**CITY OF ALBANY  
PLANNING AND ZONING AGENDA  
STAFF REPORT**

**ITEM:** 6C

**SUBJECT:** Planning Application 11-048. Design Review 810 Jackson St.

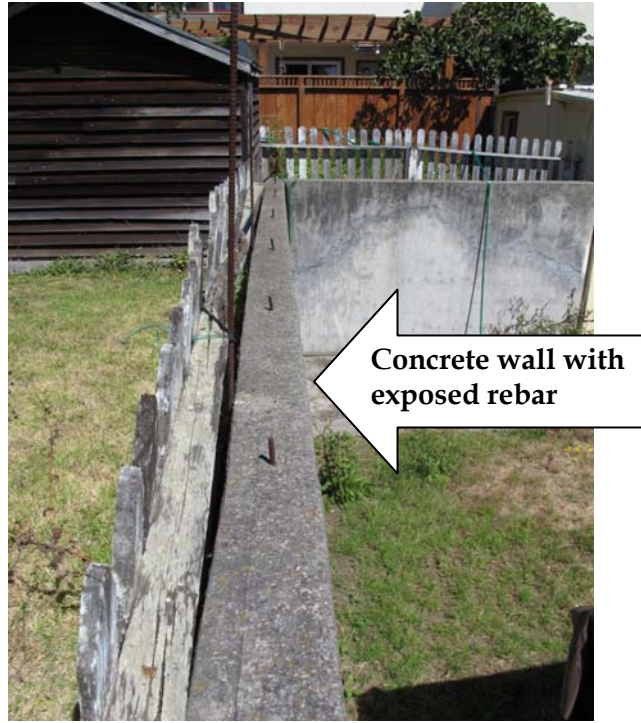
The single-story front portion of the home (which faces the street) will have a side-gabled roof. An entry porch will be located on the south elevation and will be the primary entrance to the home. The second story elevation is setback 16 ft. from the front of the house, is approximately 25 ft. in height from the grade. The second story will have a front gable roof.

Two (2) balconies are proposed. One balcony will be located on the second floor, accessible from the master suite. The other balcony is located above the garage and is accessible from the second-story loft area.
